Preservation Department – Item 1, LPC-23-08657

**346 Broadway (aka 108 Leonard Street, 46 Lafayette Street) – Former  
New York Life Insurance Building – Individual and Interior Landmark  
Borough of Manhattan**

# DESIGN REVISIONS

## IN RESPONSE TO COMMISSIONER COMMENTS

5 RENDER

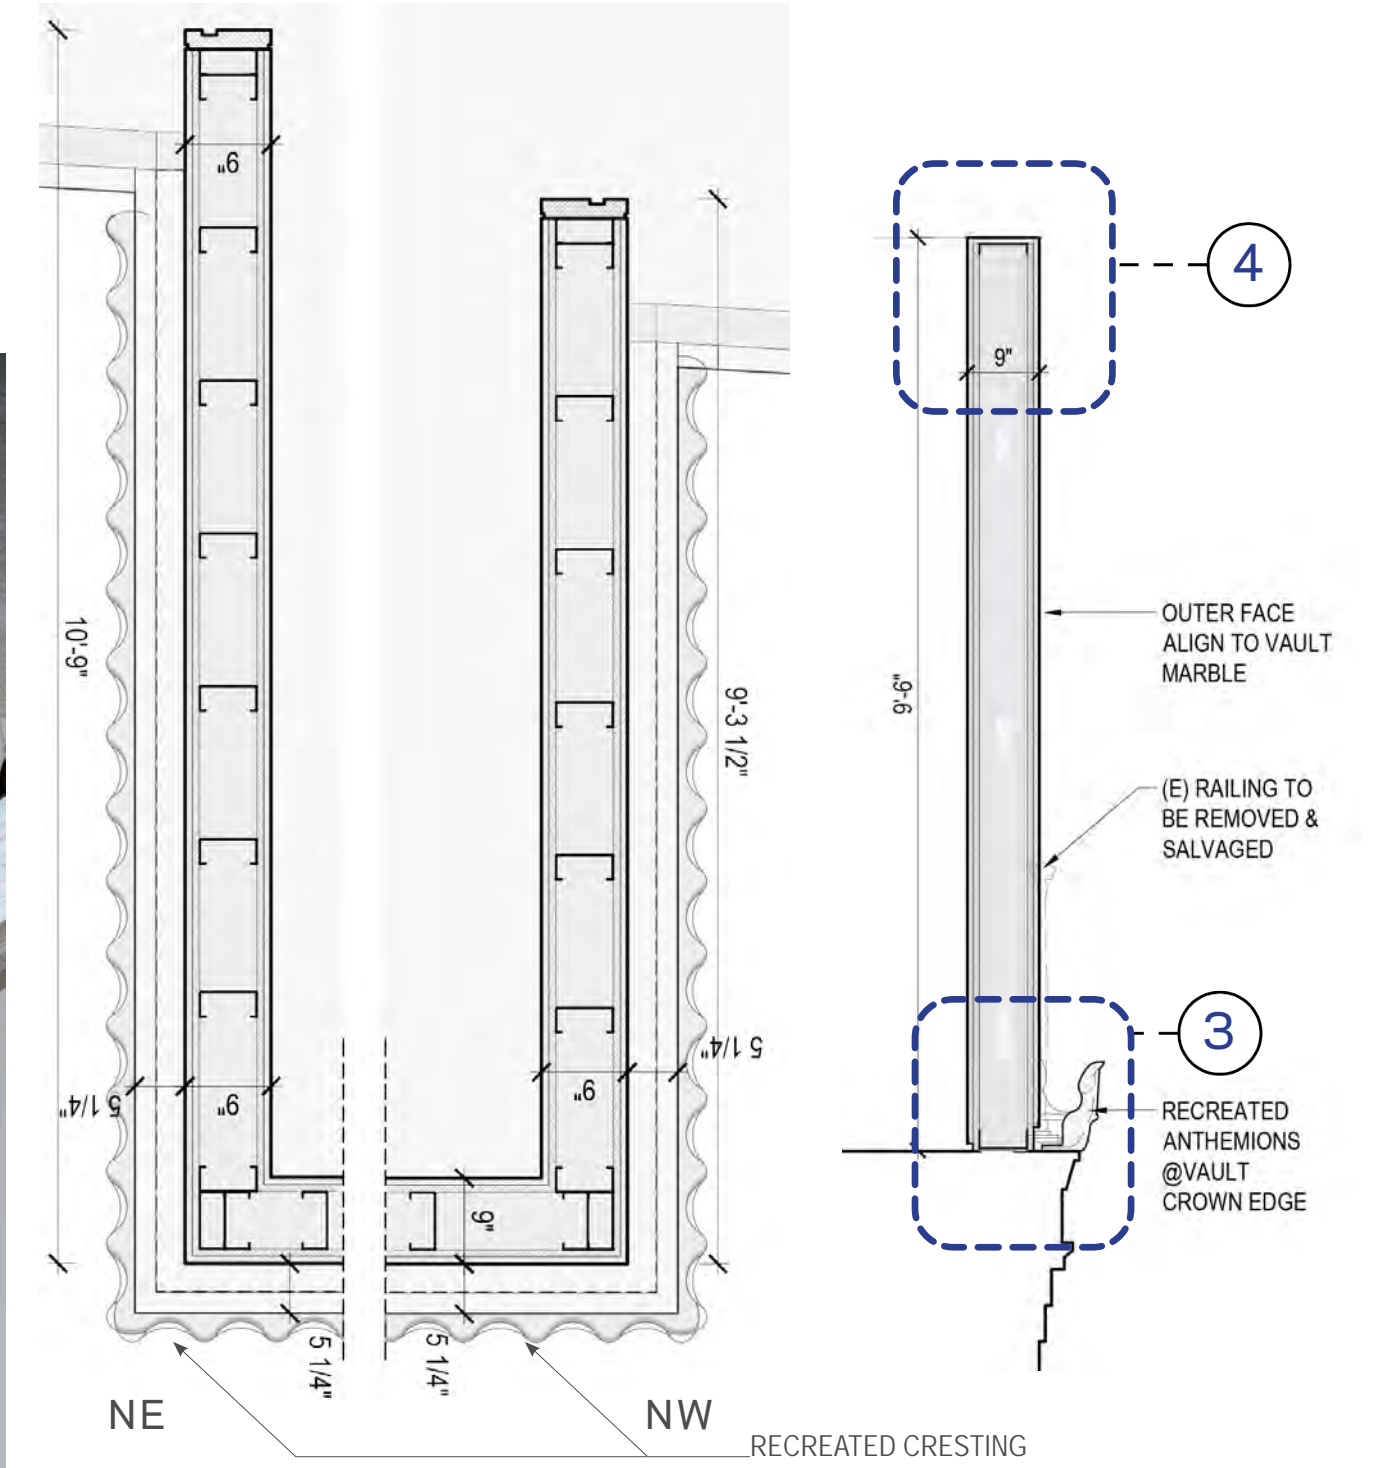
To address the commissioners' concerns about the design, detail and impact on the vault and its relationship to the overall space, the feature wall has been eliminated and the enclosure reconfigured in a symmetrical composition, an interpretation of the solidity and regularity of the vault below. The partitions are set back to the recessed plane of the marble, allowing the cornice to project from the facades. Recreated cresting, which originally existed at the vault's top, provides a stronger termination to the vault. A reveal at the base of the enclosure will provide a physical and visual break above the cornice.

## PARTITIONS

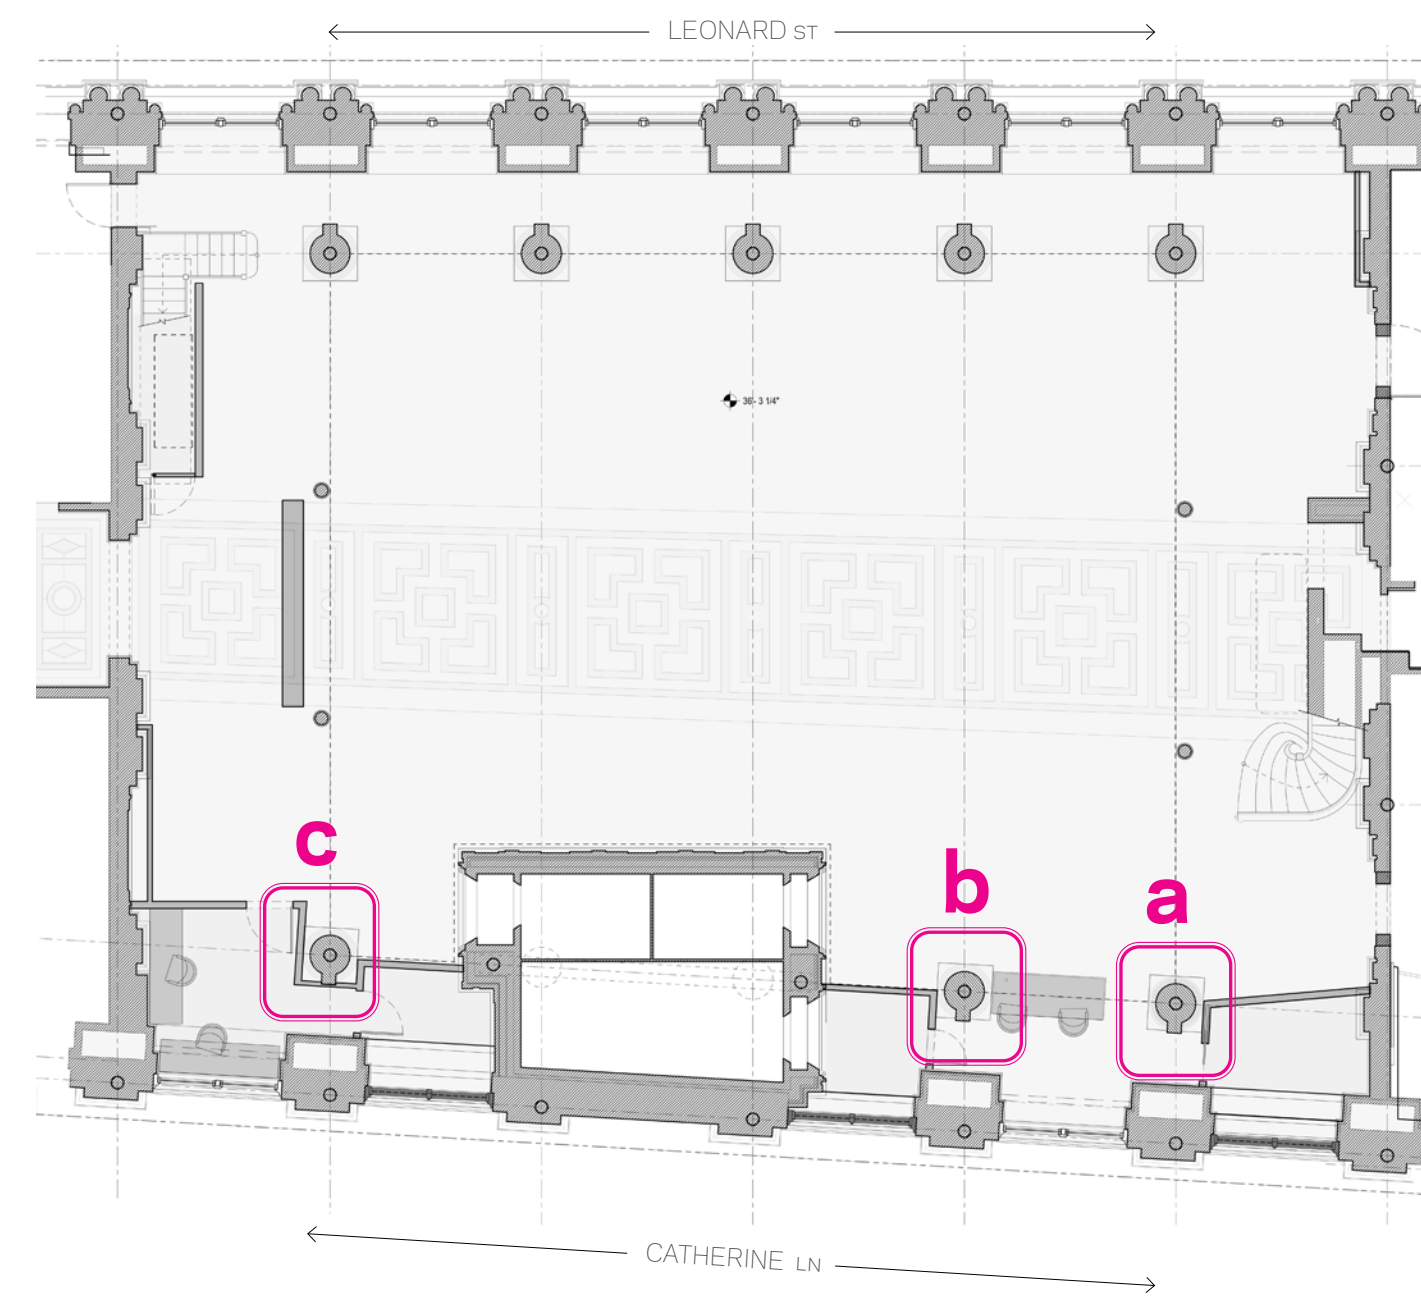
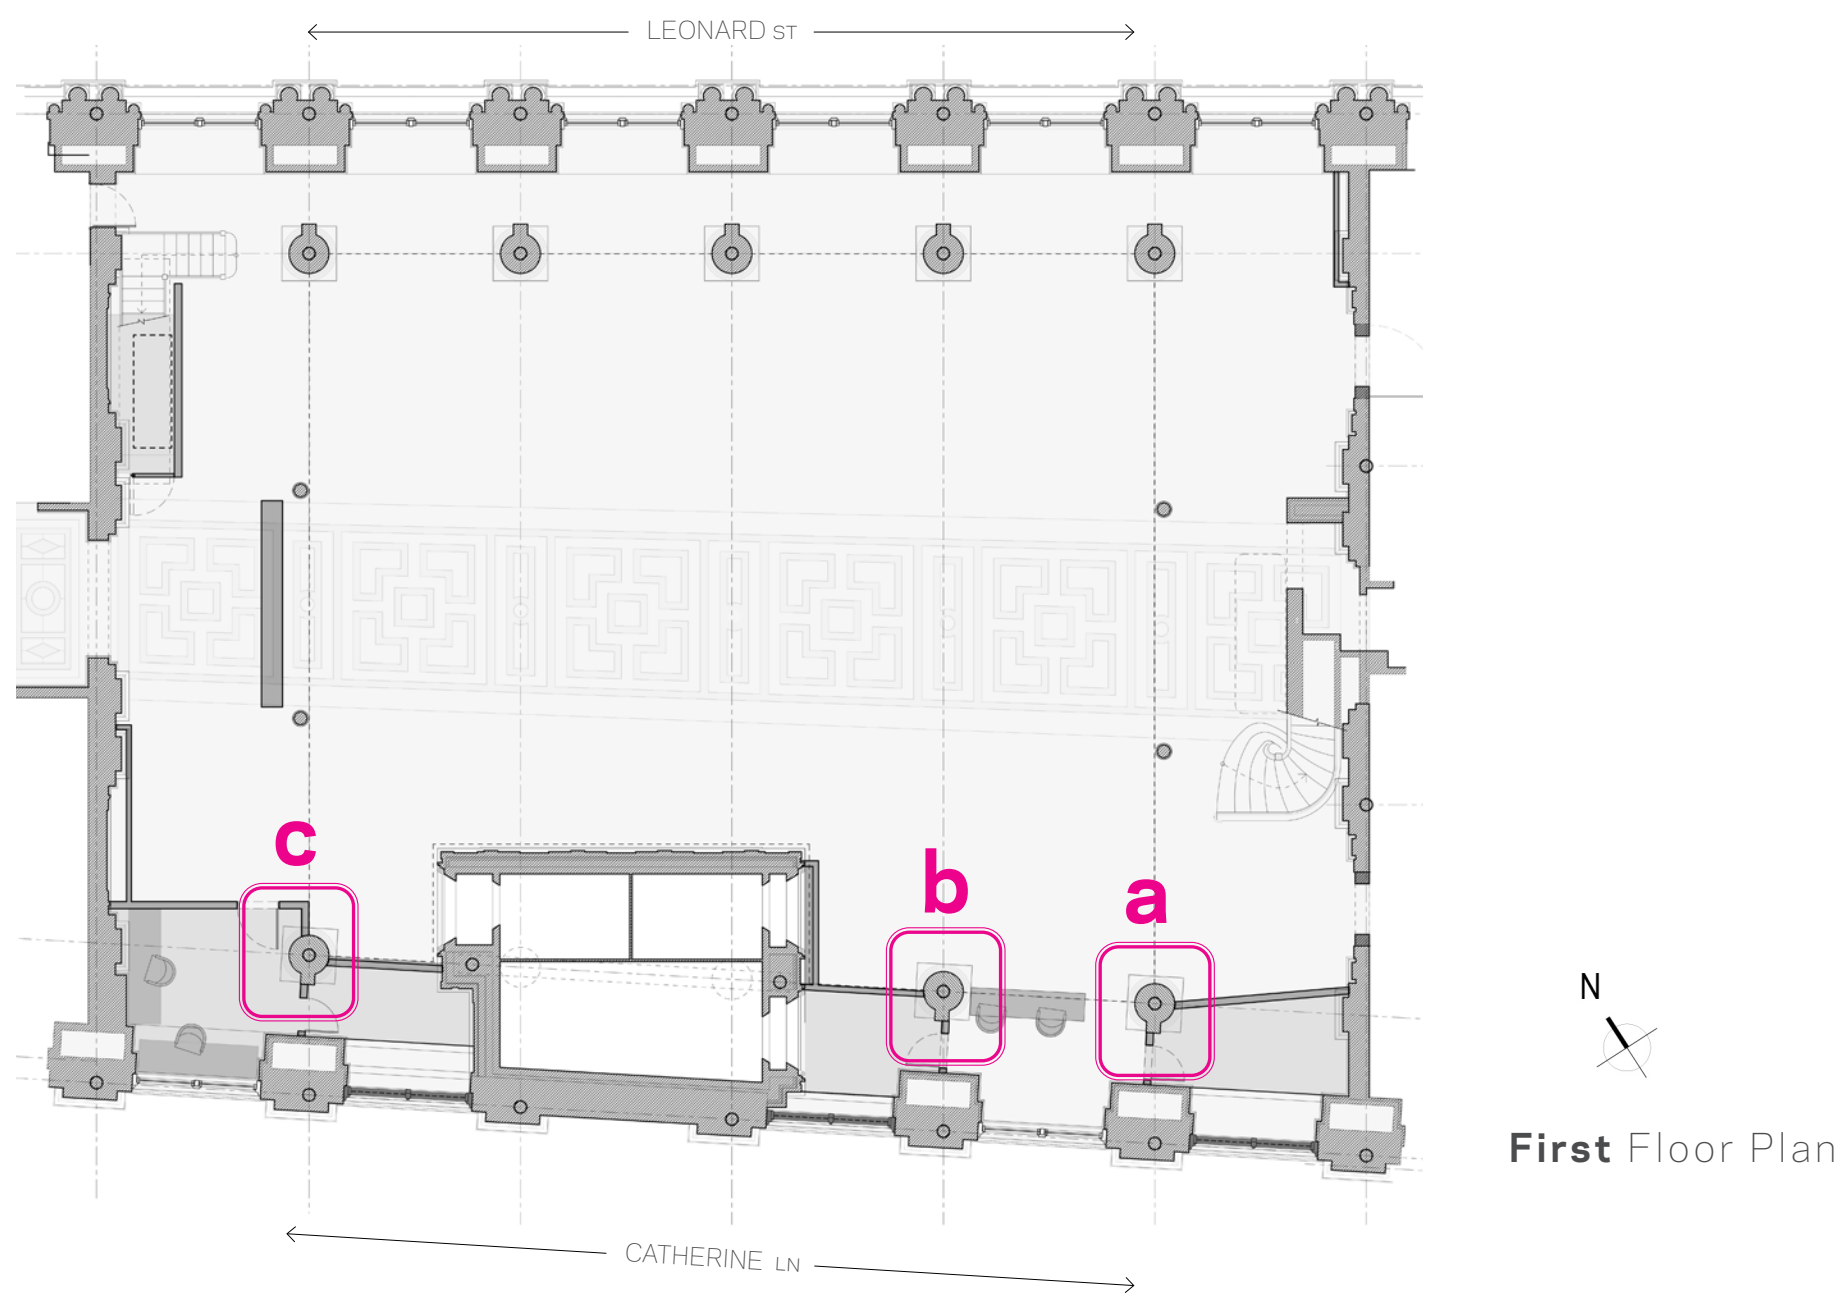
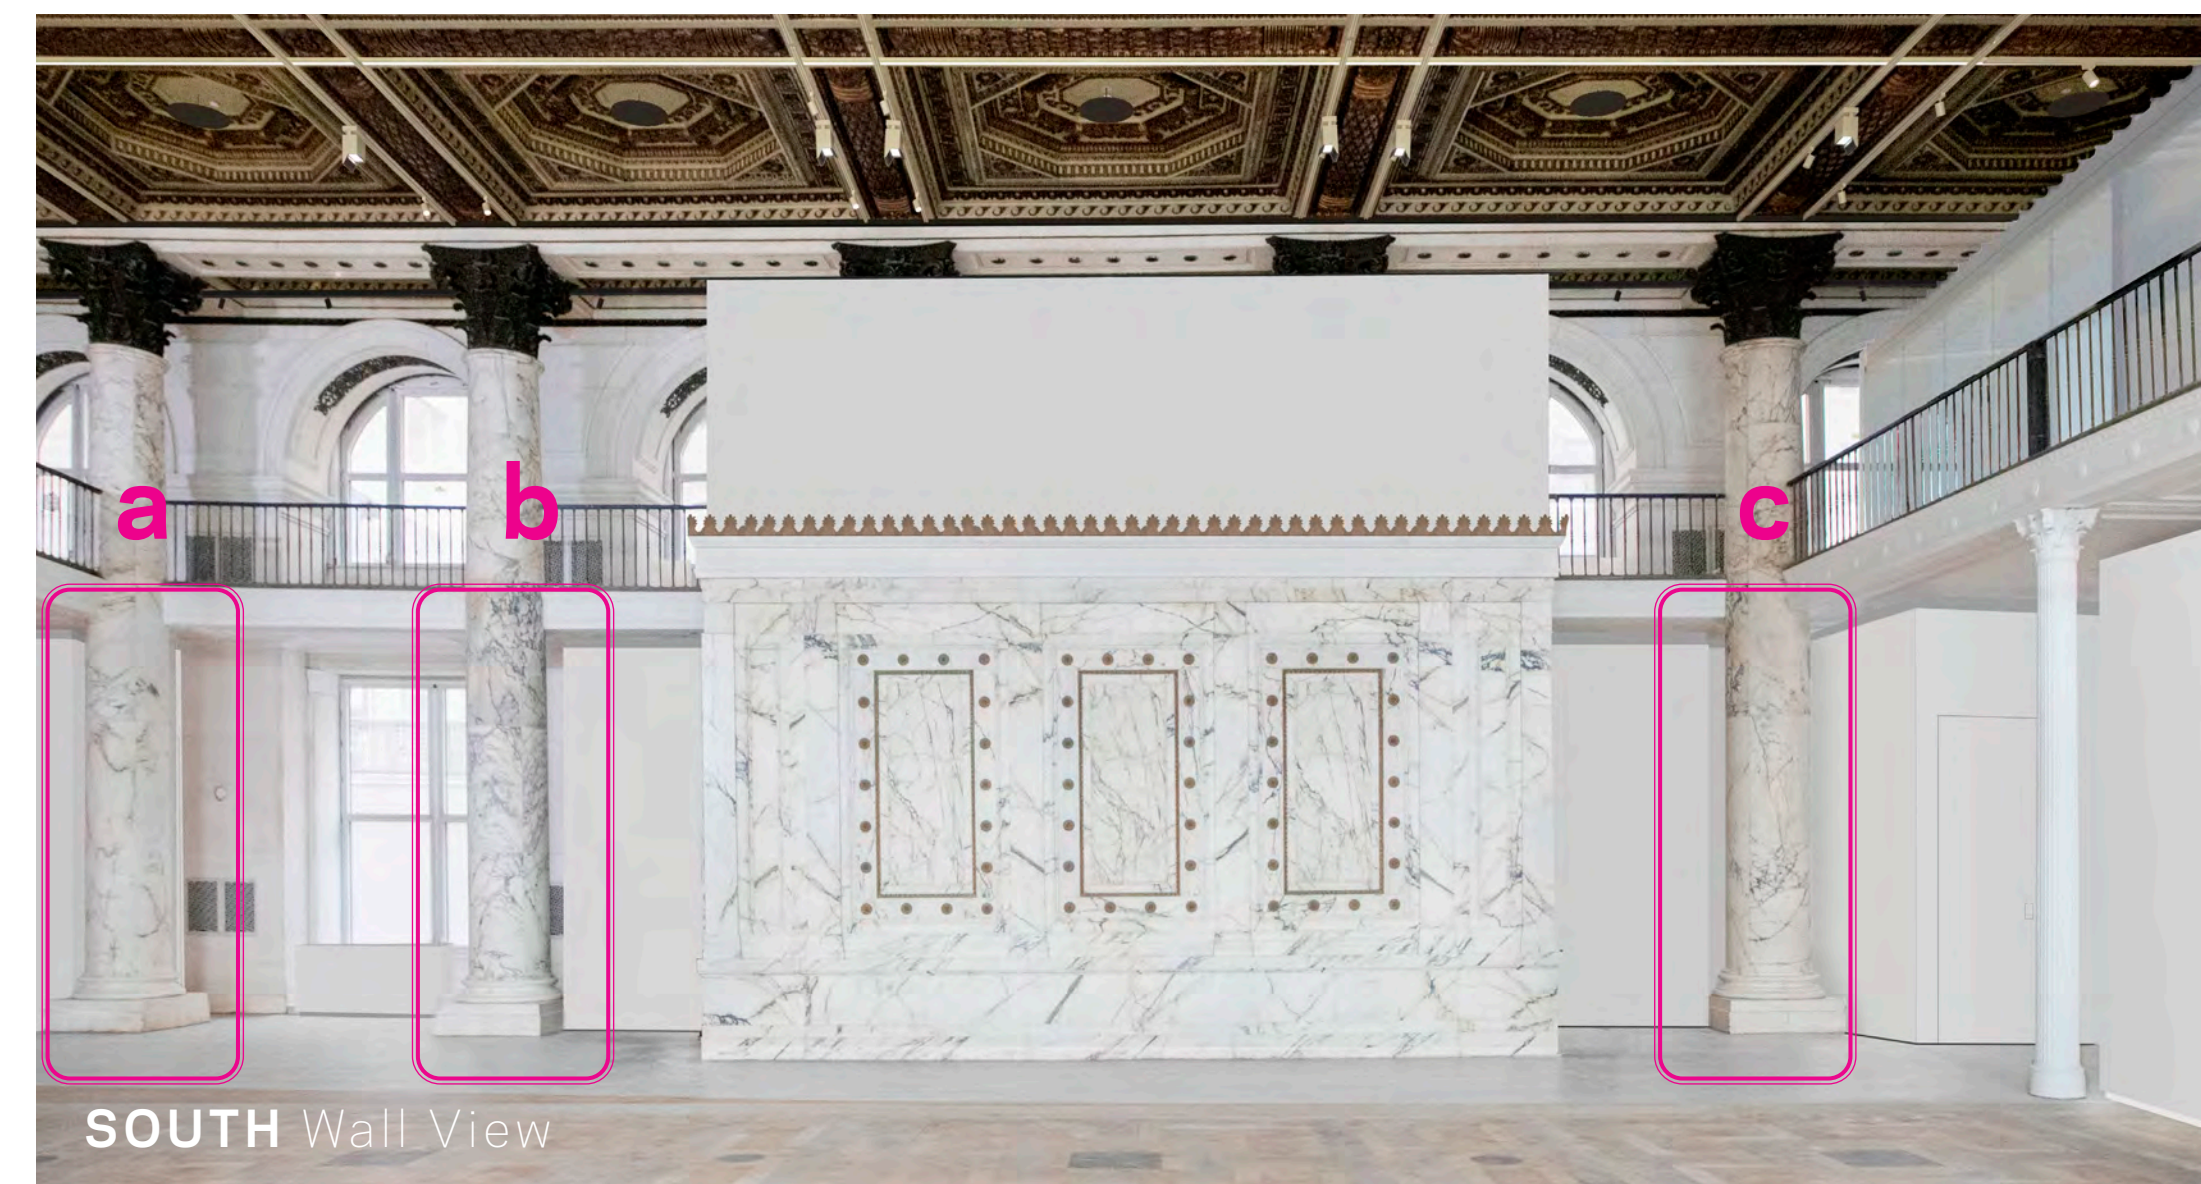
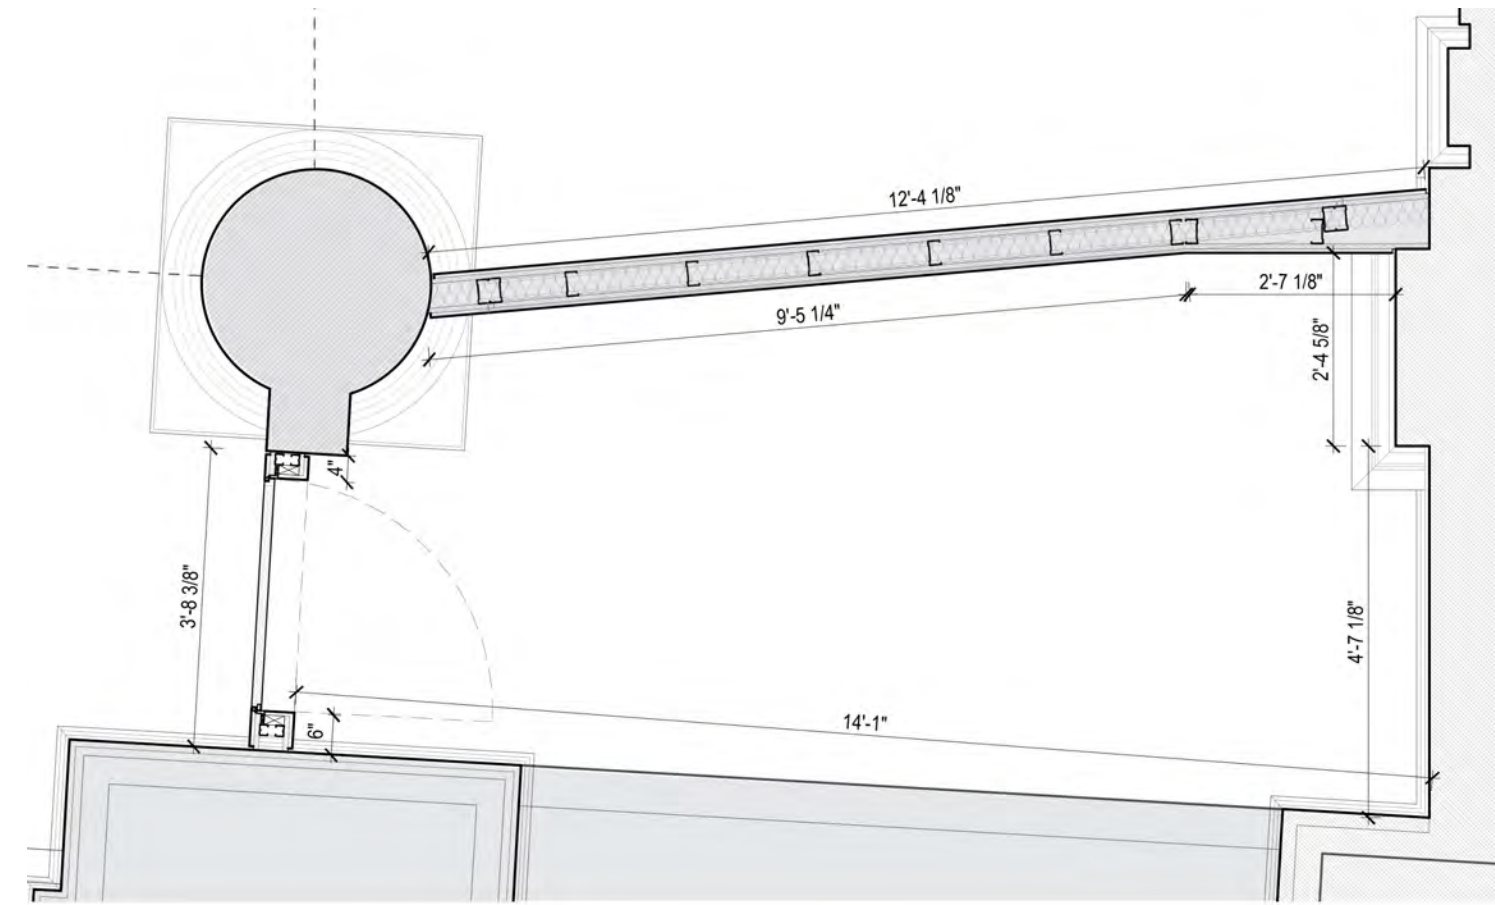
The partitions under the mezzanine have been reconfigured and no longer engage at the columns. The partitioned spaces are tucked behind the column line in deference to the columns while still providing a minimal footprint required for gallery operations
